PROPERTY ADDRESS: 4253 Linthicum Road

RE: **4253 Linthicum Road, BAT Site Plan and LPD design: comment**

RE: **4253 Linthicum Road, BAT Site Plan and LPD design: comment**

PERCOLATION TEST RESULTS, A-526195		
SITE PLAN FOR BAT INSTALLATION 4253 LINTICUM ROAD LOT 2 LEVINE PROPERTY		
PLAT MDR 20574 TAX MAP 22 GRID 19 PARCEL 217 ZONING: RR-DEO 5th ELECTION DISTRICT HOWARD COUNTY, MARYLAND		
 Linda D. Alexander Qualified Professional		 CLSI www.clsi-civileng.com 439 East Main Street Westminster, MD 21157-5539 (410) 848-1790 FAX (410) 848-1791
Date	Revisions	Drawn By: BM
11/13/13	REV'D TRENCH DESIGN AND LAYOUT PER HC COMMENTS	Designed By: LDA
		Reviewed By: LDA
		Date: 3/24/14
		Scale: 1" = 40'
		Job No.: 2006208
		Sheet: 1 OF 2

TYPICAL TURN-UP & OBSERVATION PIPE DETAIL
NOT TO SCALE

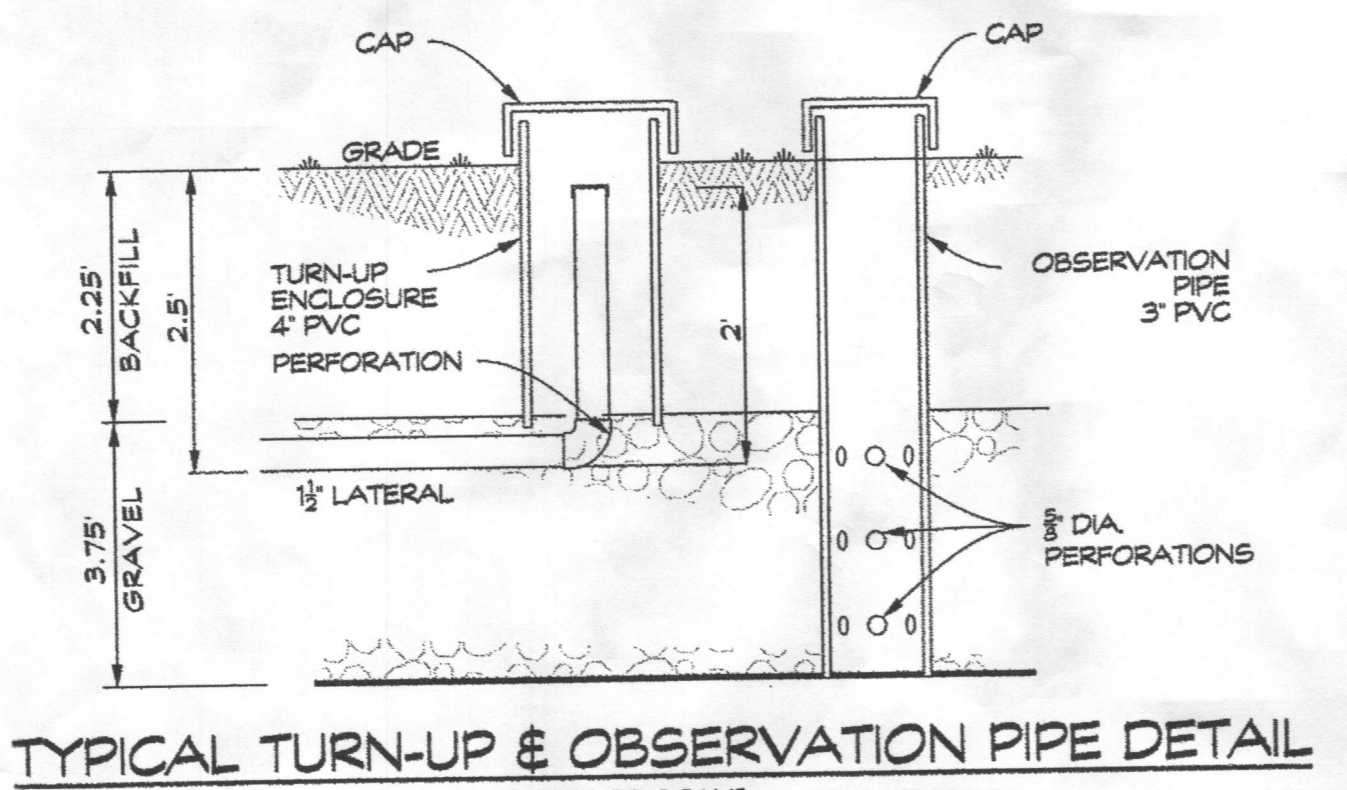
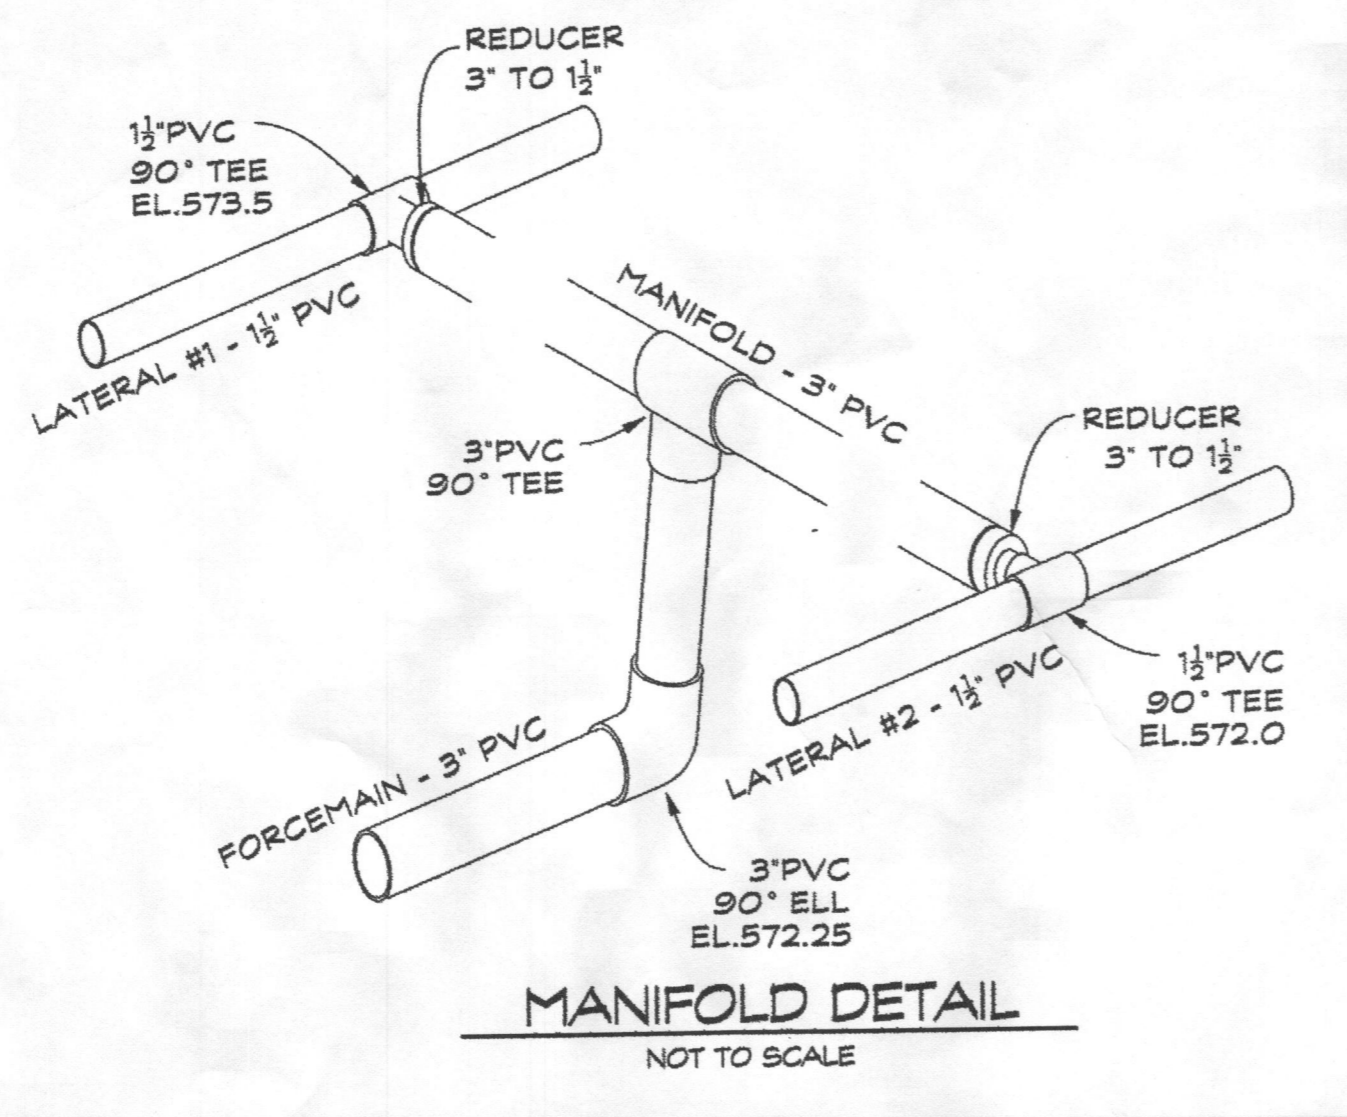
8. In detail for Typical Turn-Up,
 - Illustrate the last perforation at the outer arc of the ell (i.e., $\frac{1}{2}$ -interval from the trench end), and at the same elevation as the crown of the lateral.

- Label the height from the Invert of the lateral pipe to the cap of the Turn-Up as 2 feet.
9. Enlarge the Pump Curve graphic a little more. It's very 'grainy' and I still need a magnifier to read the pump model labels.

10. The Observation Pipe Detail is incomplete.
 - While the enclosure of the turn-up at the end of the lateral is correct,
 - There is an observation pipe that extends to the bottom of the trench.
The observation pipe has

- May be 3-inch or 4-inch diameter, and
 - Has three rows of perforations approx. 5/8-inch diameter.
 - An observation pipe is located at each trench end.

1500 GAL. PUMP CHAMBER
NOT TO SCALE

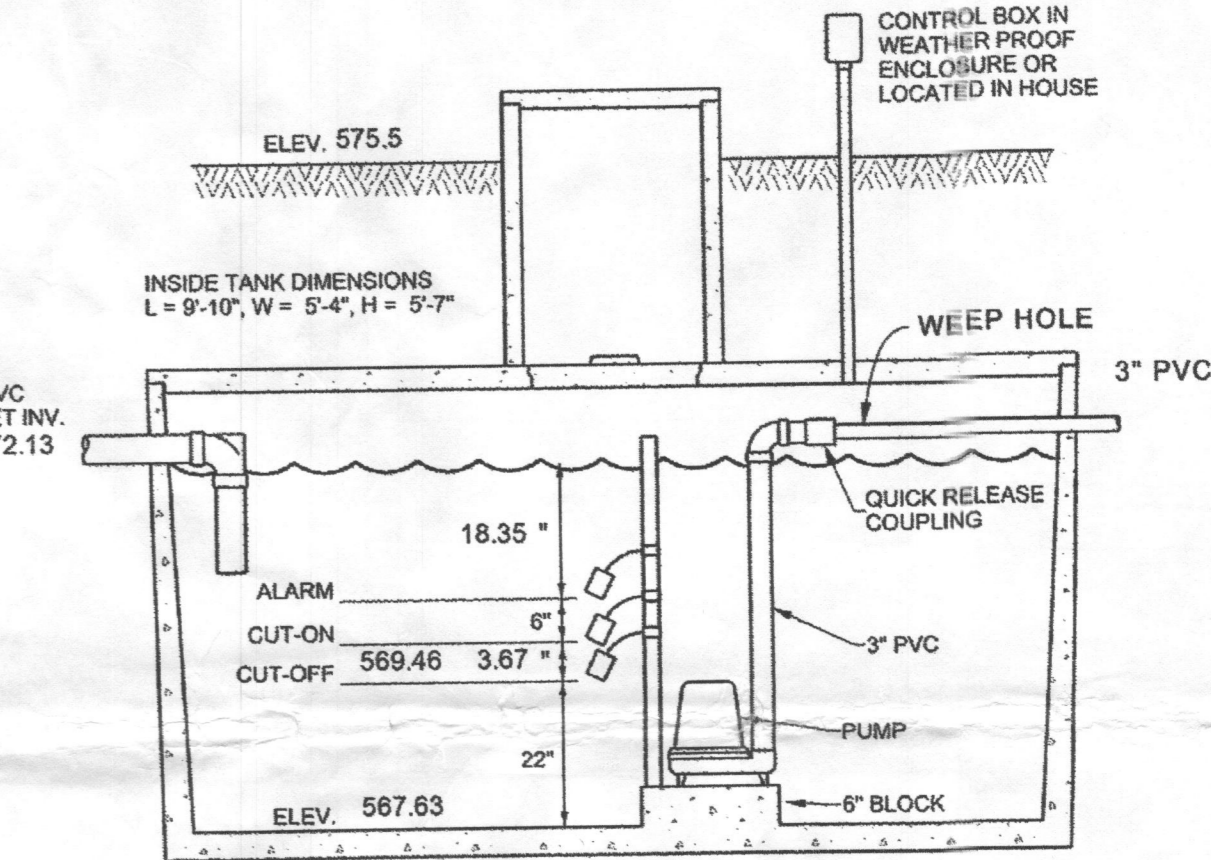
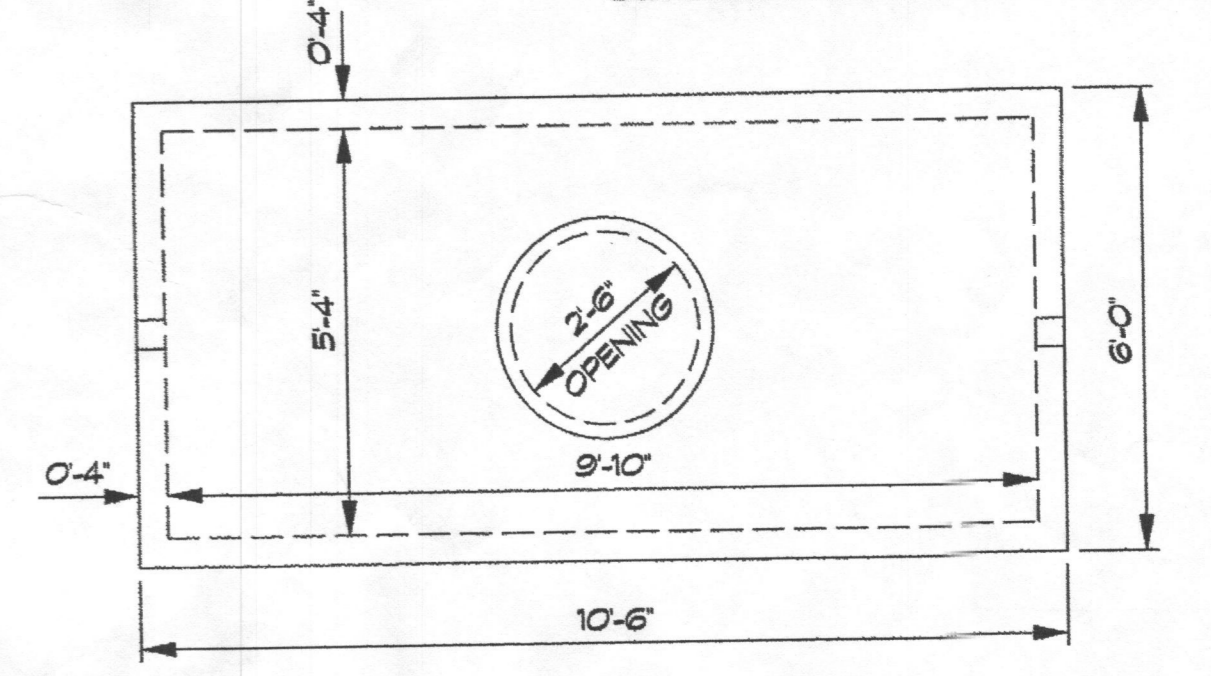
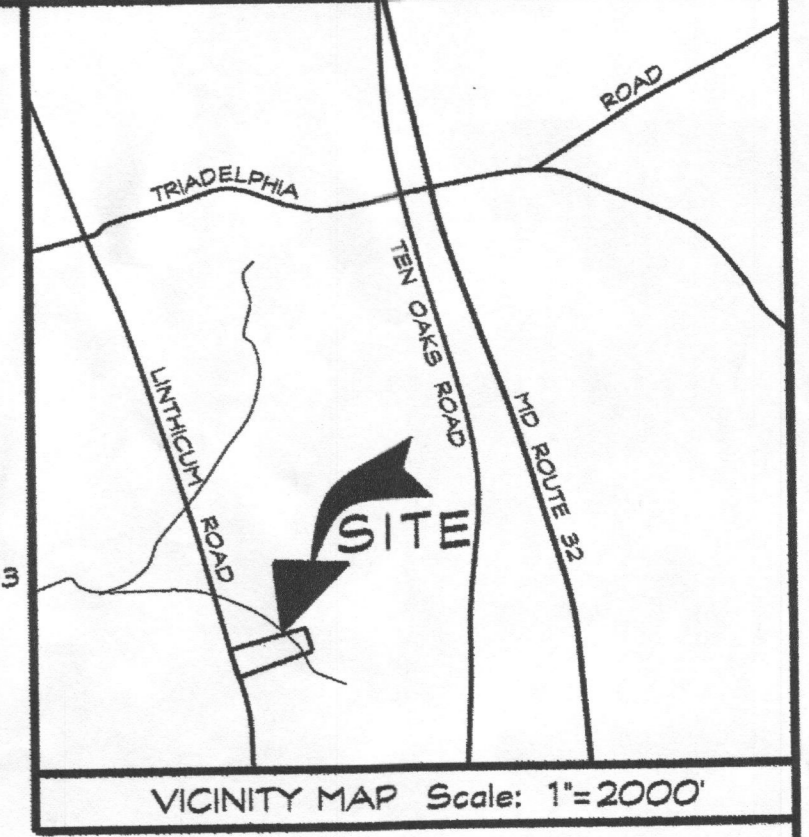
7. In the detail for the 1500-gallon Pump Chamber,
 - Label the distance between the Cut On and Cut Off the same as indicated in your calculation for 120-gallon dose (i.e., 3.67").

- If you must shift the elevation of one of the floats, MOVE THE CUT OFF FLOAT down, and edit the distance from bottom of chamber.
 - Be advised that the outlet is supposed to be sealed so the Max. Water Level in the tank should be the same as the Inlet, "572.00". You may delete the label for Max. Water Level.

8. In detail for 1500-Gallon Pump Chamber, correct the label for the inlet pipe as it is 4-inch PVC.
9. Add a detail top view with dimensions labels for the Pump Chamber
